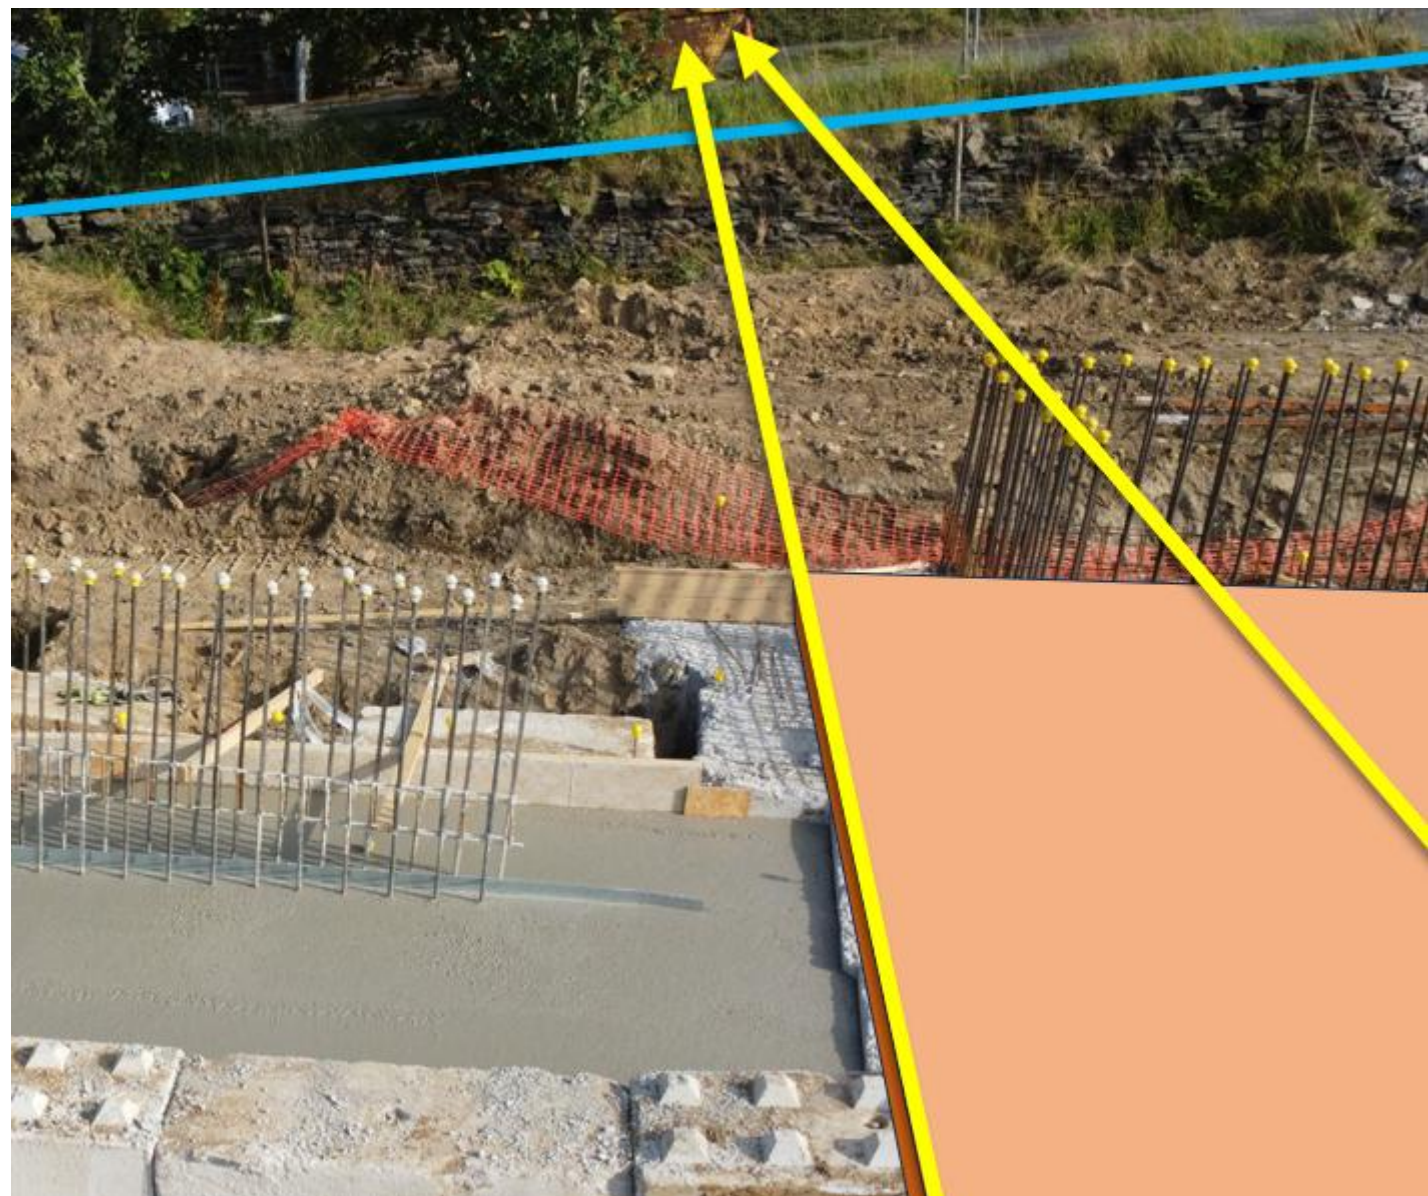
No matter which direction or angle I look at the house at plot 23, it all demonstrates the significant height of the north facing gable end.

The applicant wanting to increase the elevation, as part of this application, and their latest site related application (2025/91887), is evidence enough that elevation is one their highest priorities.

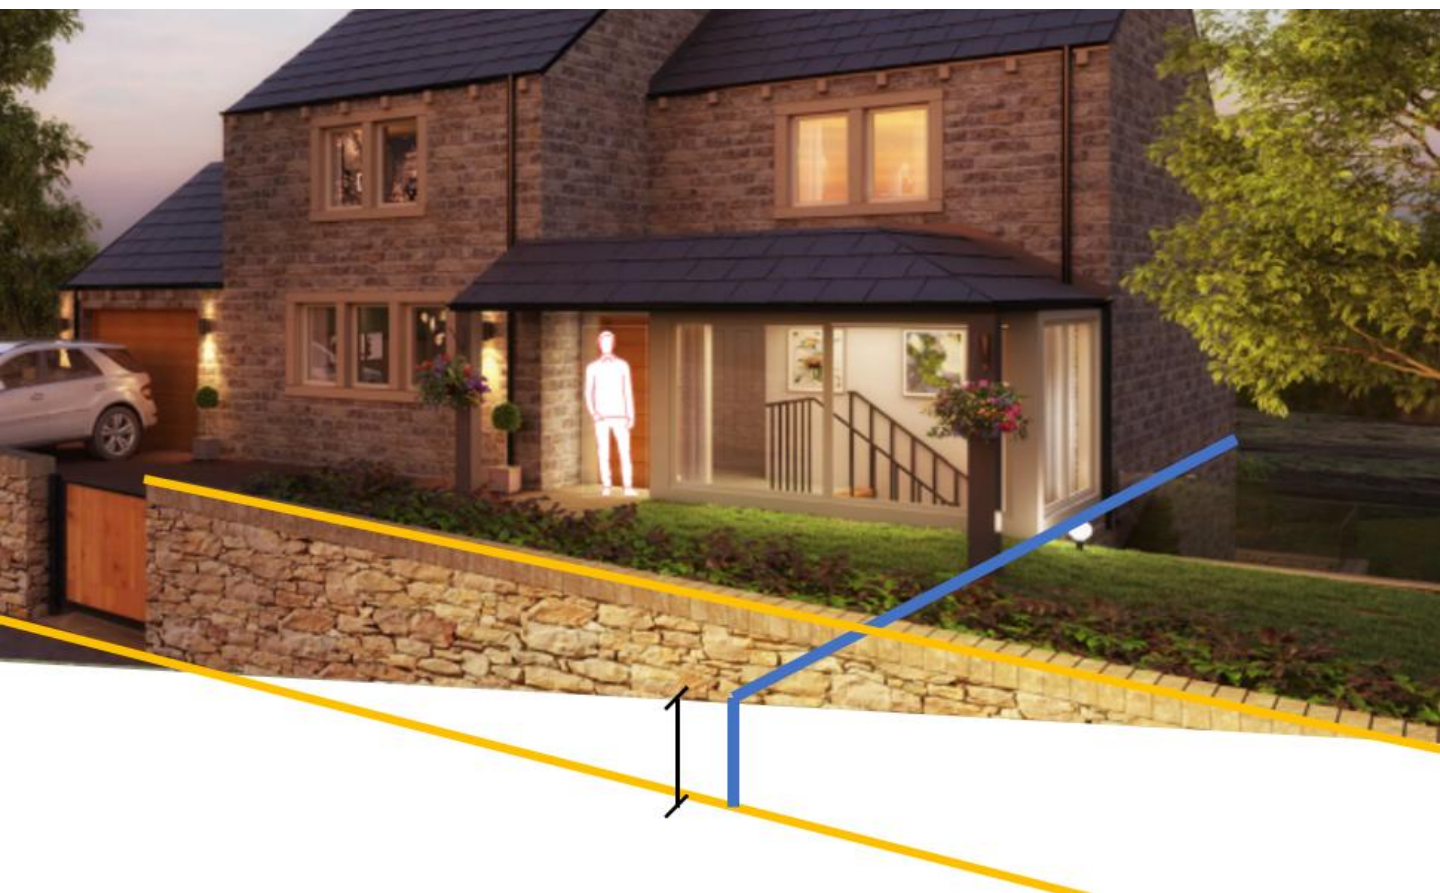
All indications are that the elevation of the lower ground floor, at plot 23, will be significantly higher than the existing elevation of Lingards Road. This will raise the rooves and increase the house's dominance.

The drive is meant to have a gradient of 1/15, sloping down to the garage, and house facade.

Seating the house higher than the road – as the blue line illustrates - must surely mean the slope would be up to the garage, and house façade. That is certainly what the CGI reflects: the car is sloping downward, toward the road.

That blue line indicates how much higher the Ground Floor would be. It is not insignificant, and cannot be ignored.
